<b>CASE</b>	UDP-A25038
<b>PROJECT NAME</b>	Ombelle
<b>APPLICATION TYPE</b>	Site Plan Level II (RAC) Amendment
<b>APPROVAL LEVEL</b>	City Commission Approval
<b>REQUEST</b>	Deviation Requests for Streetwall Length, Increased Podium Height, Increased Floorplate Size with Reduction of 186 Units and Reduction of Parking to 151 Spaces
<b>APPLICANT</b>	Dependable Equities, LLC.
<b>AGENT</b>	Stephanie Toothaker, Esq.
<b>PROPERTY ADDRESS</b>	300 NE 3 <sup>rd</sup> Avenue
<b>ABBREVIATED LEGAL DESCRIPTION</b>	Geo M Phippens Sub Lots 3 To 6 Blk 1 & Lots 3 To 10
<b>ZONING DISTRICT</b>	Regional Activity Center – City Center (RAC-CC)
<b>LAND USE</b>	Downtown Regional Activity Center
<b>COMMISSION DISTRICT</b>	2 – Steven Glassman
<b>NEIGHBORHOOD ASSOCIATION</b>	Flagler Village Civic Association
<b>SUBMITTED</b>	July 18, 2025
<b>COMPLETENESS ISSUED</b>	July 18, 2025
<b>EXPIRATION</b>	January 14, 2026 (180 Days)
<b>WAIVER</b>	N/A

Case Number: UDP-A25038

**ENGINEERING CASE COMMENTS:**

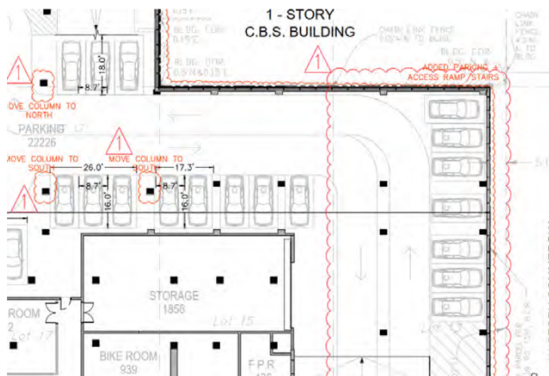
1. Include a data table showing the proposed land uses, the floor area in square feet for each land use, the parking ratio, the number of parking spaces required by type, and the number of parking spaces proposed by type (standard, compact, handicapped, vertical stacked, tandem, bicycle, loading, etc.). ULDR Sec. 47-20.2. - Parking and loading zone requirements.

**Applicant REV 1 Response:** There is no tandem parking in this Project currently. Sheet E.7 has been revised. A parking table with all required information is provided on the site plan, Sheet C0. Loading requirements are also shown on the site plan.
